RE: Safety-Kleen Wichita Facility
2549 New York St., Wichita, Kansas
EPA Identification No. KSD007246846

On behalf of Safety-Kleen (Wichita), Inc., Cameron-Cole, LLC has reviewed the comments to the RCRA Facility Investigation (RFI) Phase III Work in your letter dated June 28, 2002 and developed the following responses.

**RCRA FACILITY INVESTIGATION (RFI)
PHASE III WORK PLAN
SAFETY-KLEEN (WICHITA) FACILITY
WICHITA, KANSAS**

FIGURE 4

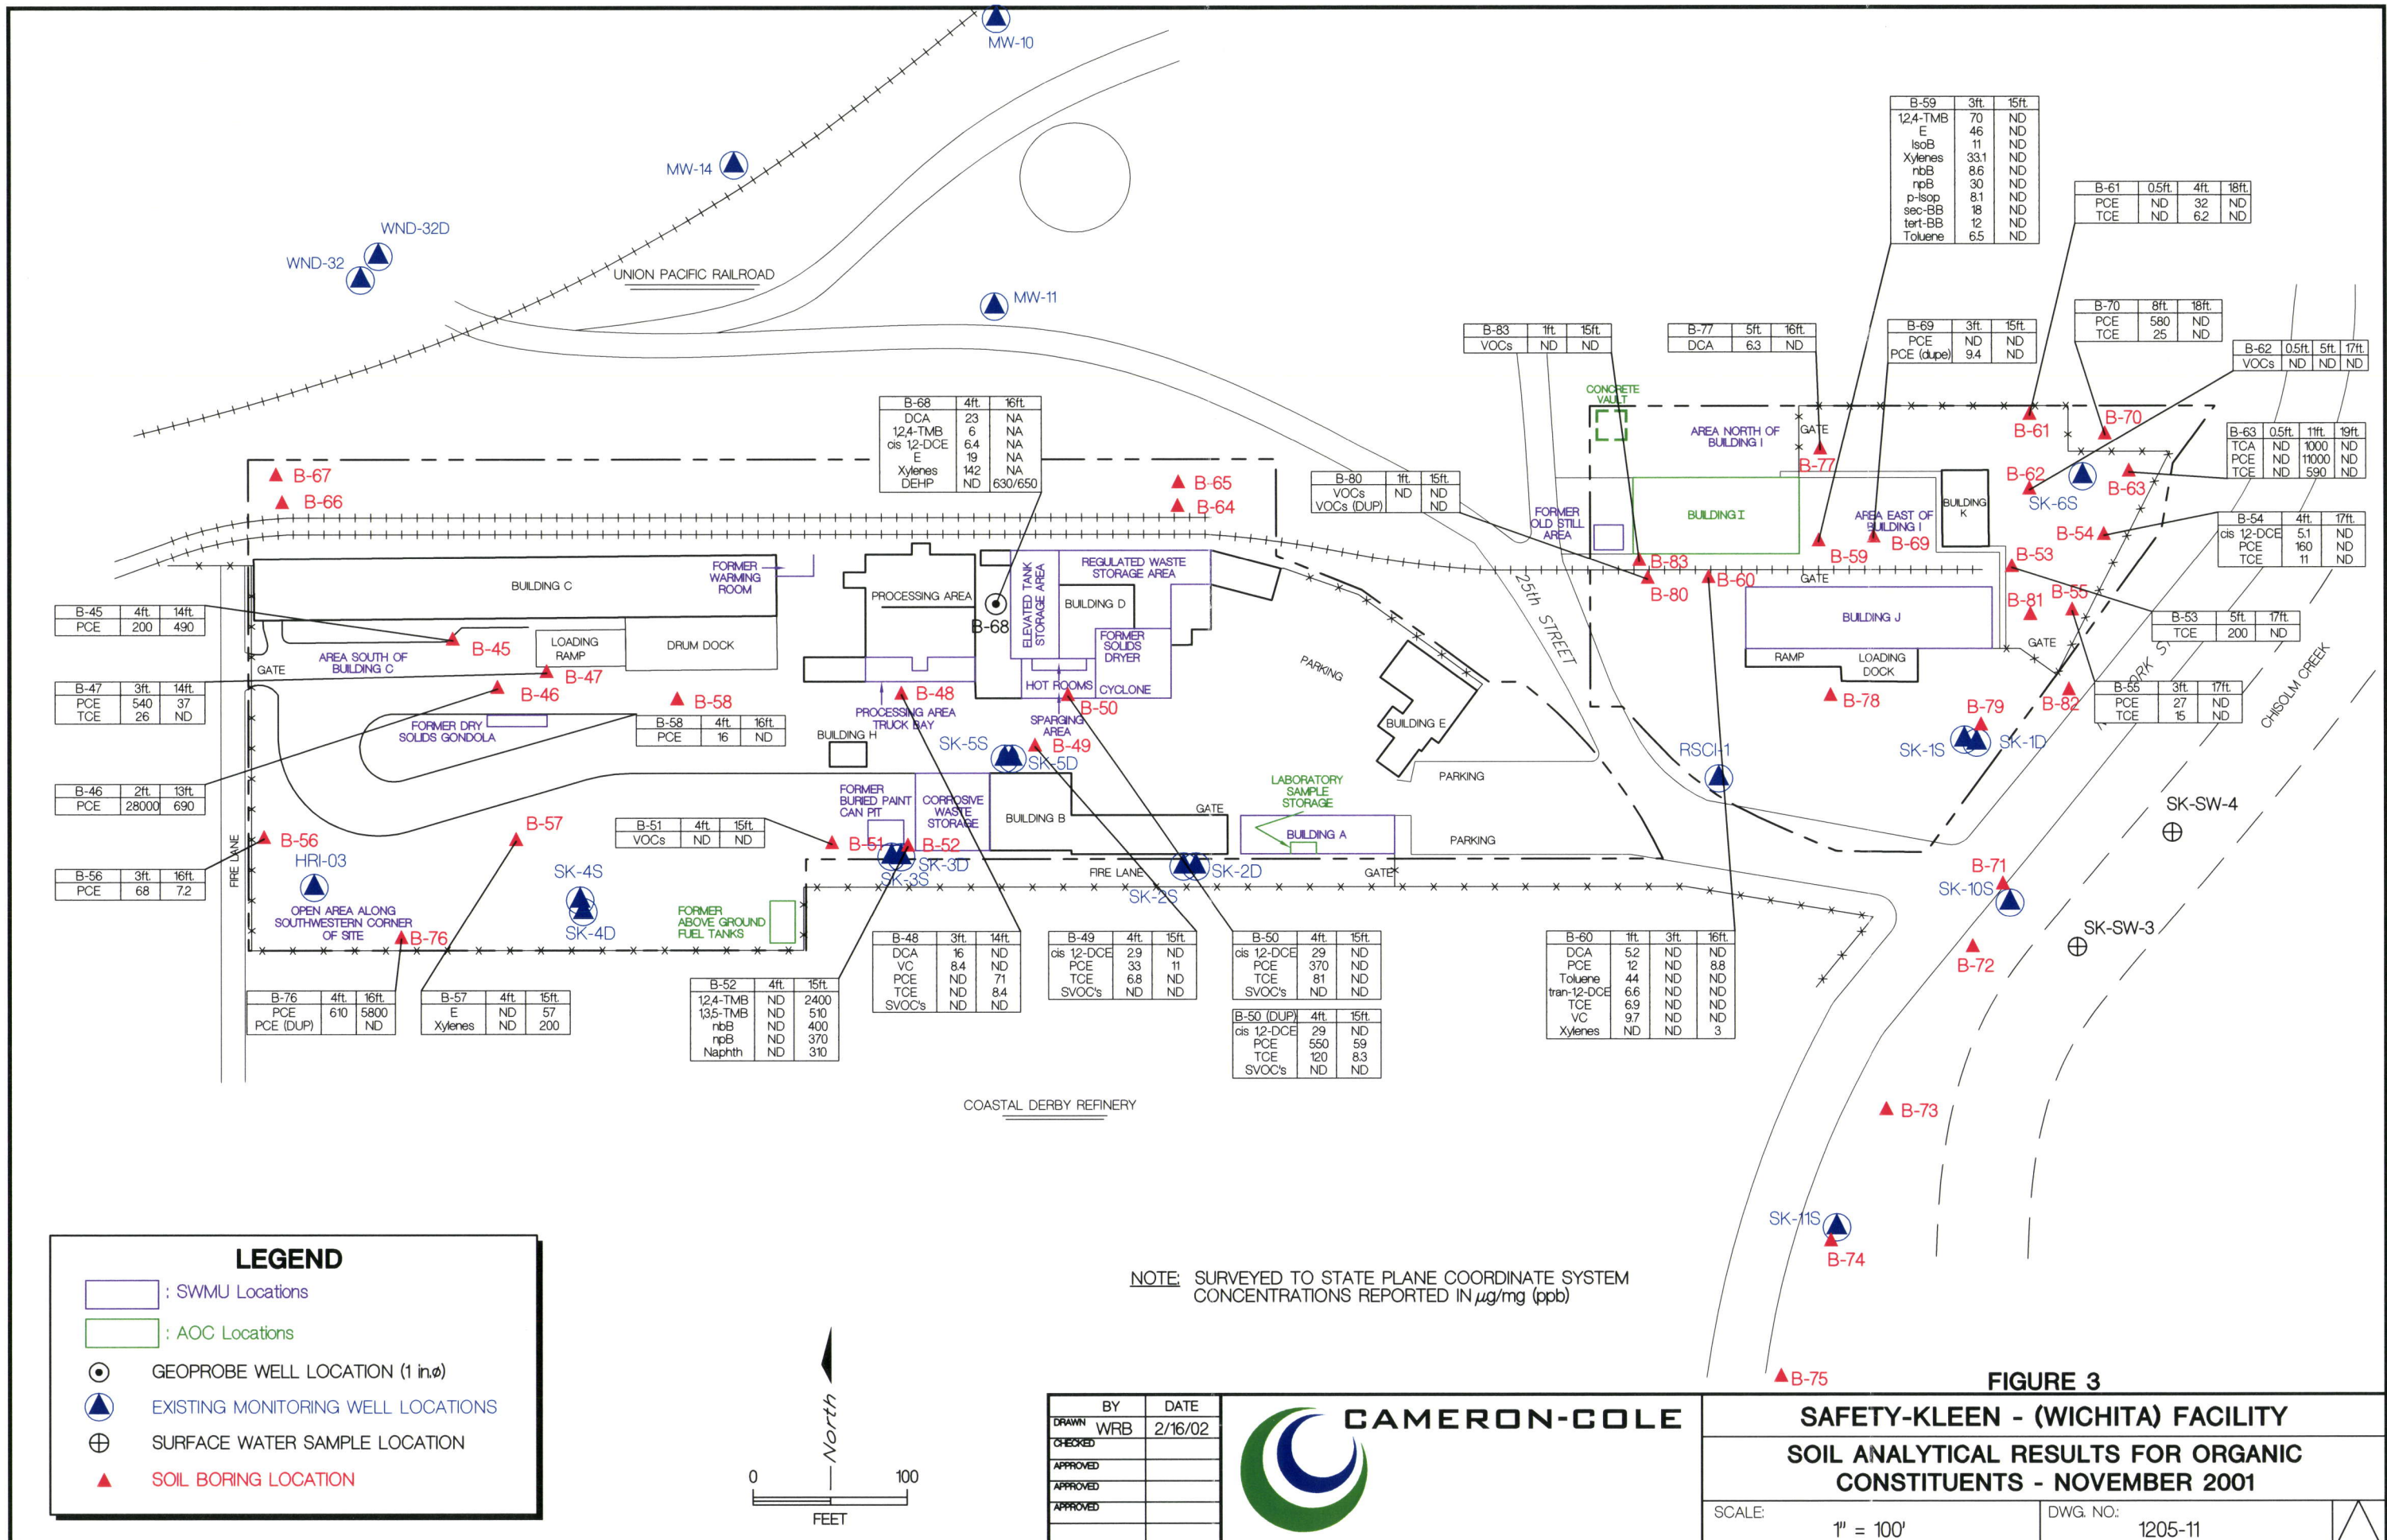
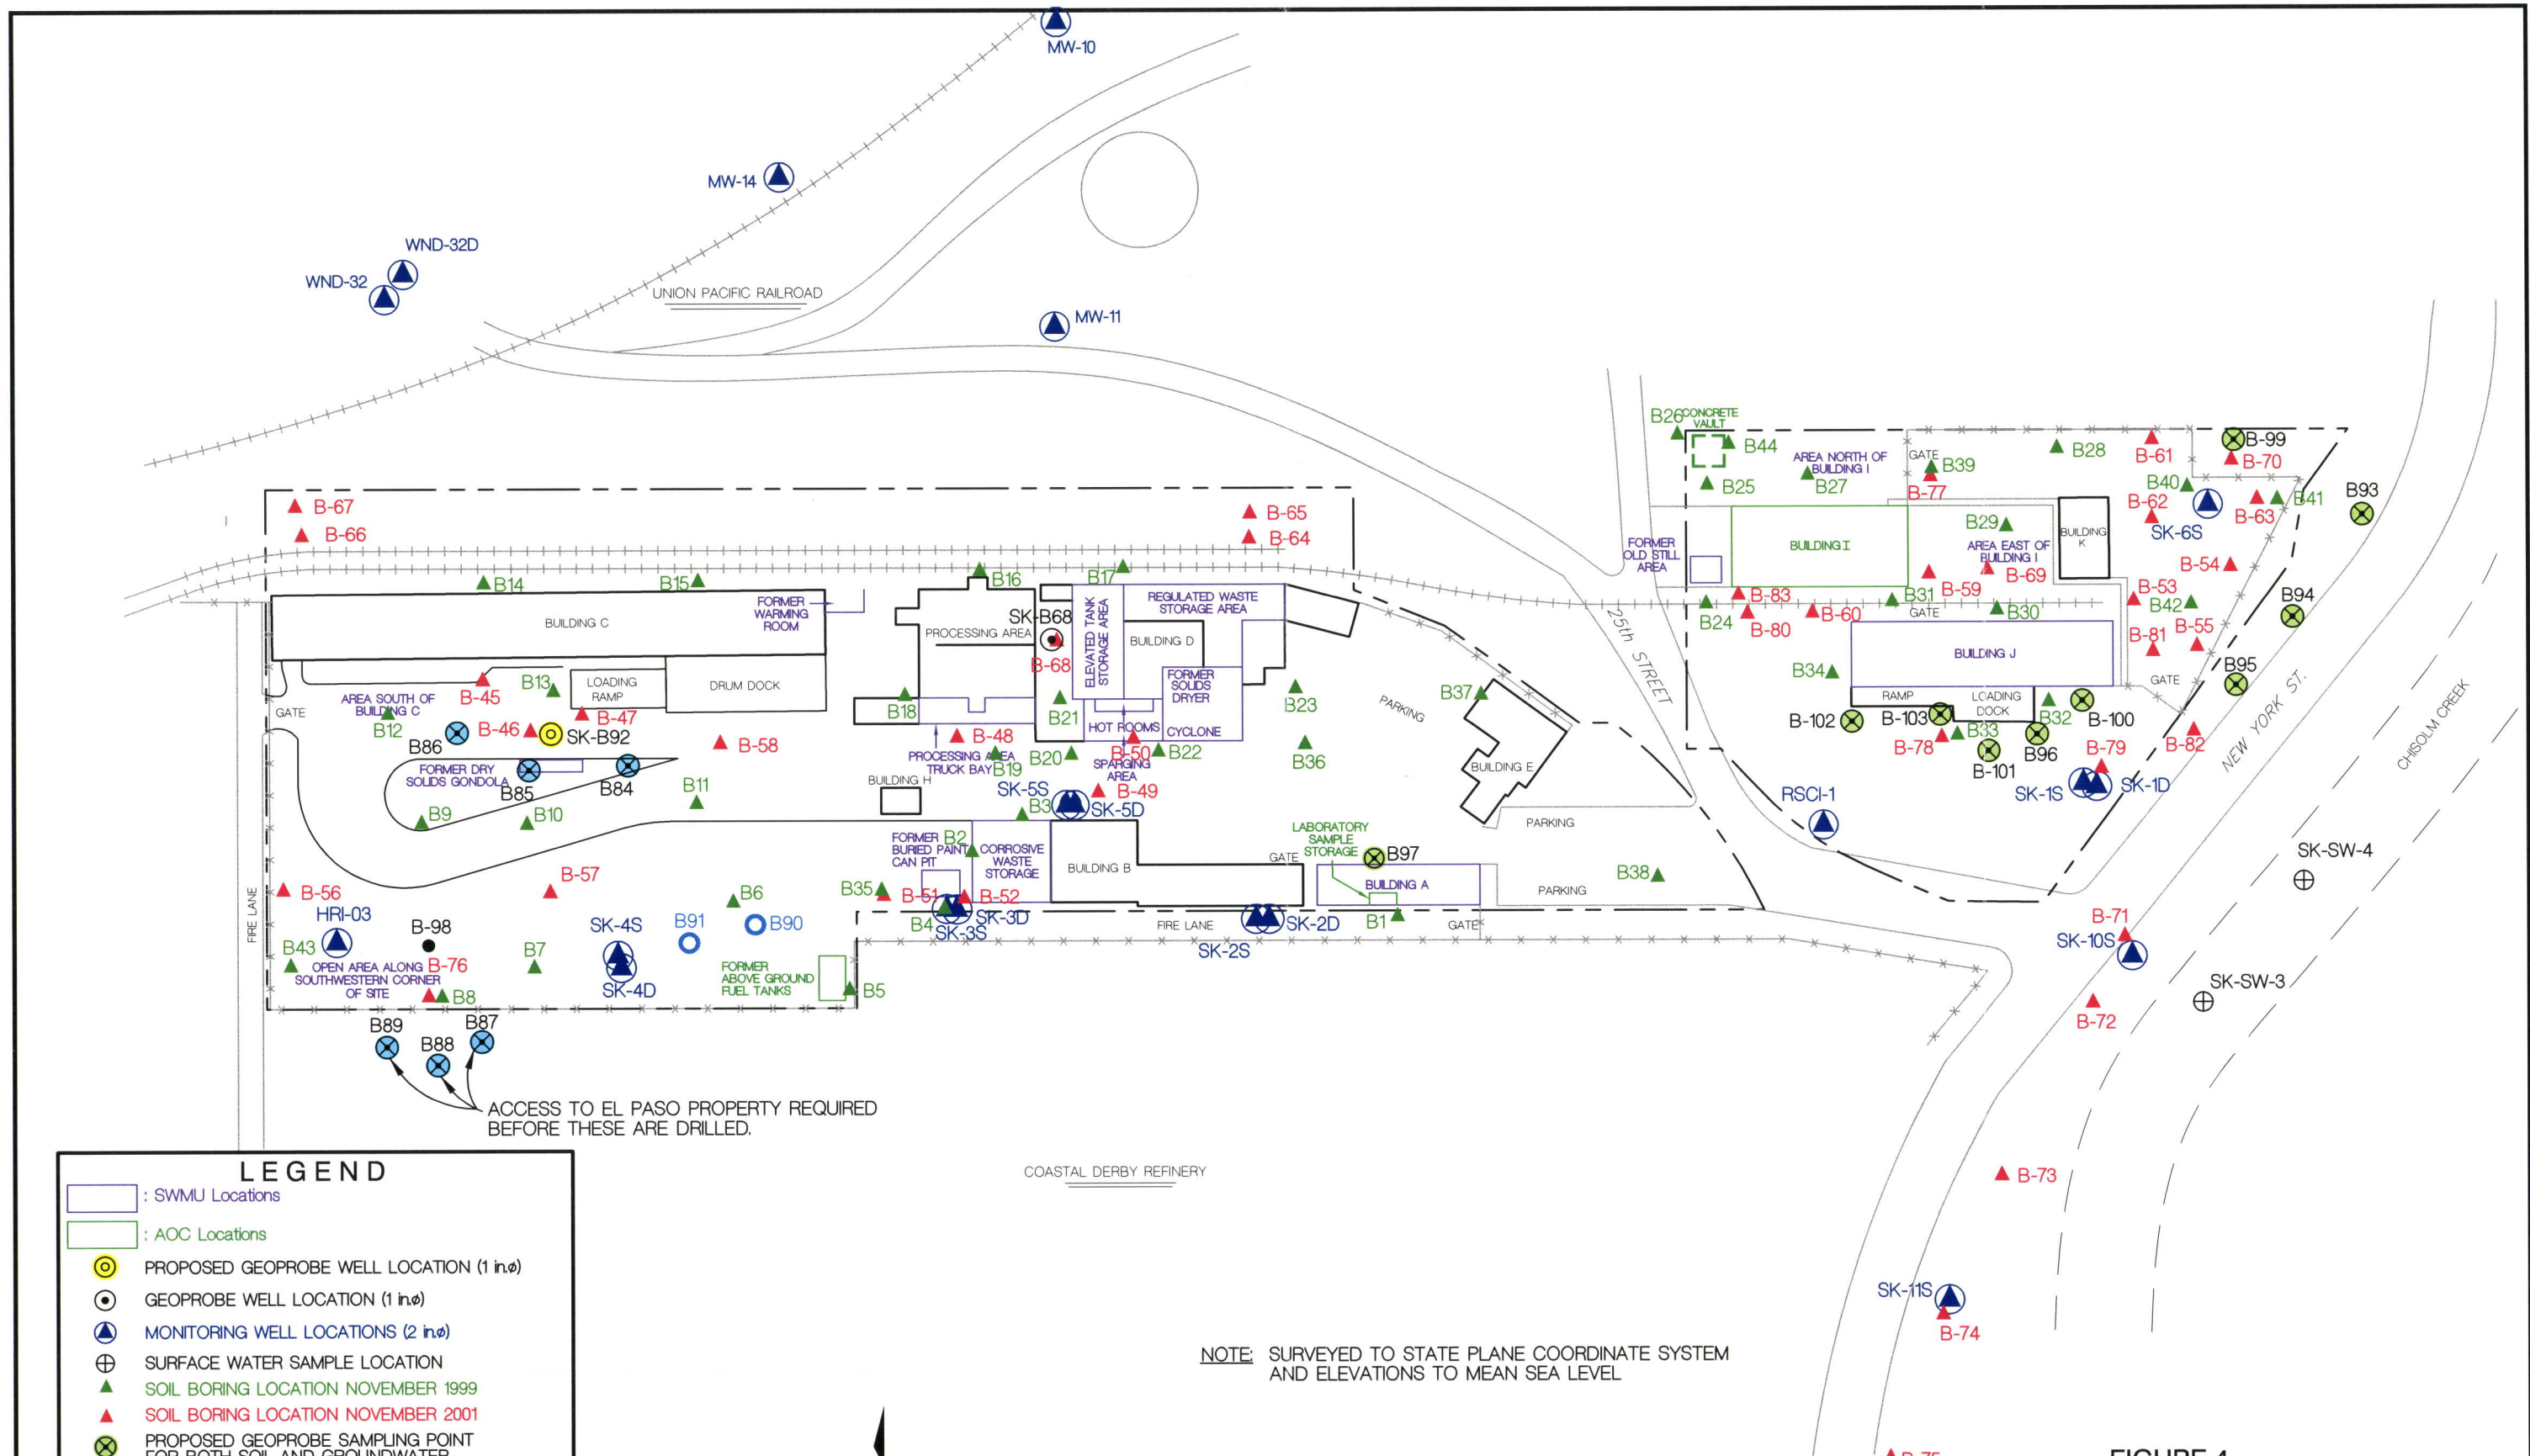
Since S-K will have to wait for analytical results from a fixed lab, S-K will have no real time basis for determining how many of the 5 potential locations will need to be sampled. To avoid potential remobilization, all of the five proposed locations should be sampled and a shallow groundwater sample should be collected from at least B-96, B-100, and B-103.

Response: Safety-Kleen intends to sample all five additional locations for both soil and groundwater, as indicated on the revised Figure 4 attached to our May 24, 2002 letter (B-96, B-100, B-101, B-102, and B-103). The term "proposed" was only used to indicate that these sampling locations had not yet been approved by the agencies; it was not intended to imply that only some of these borings would be advanced.
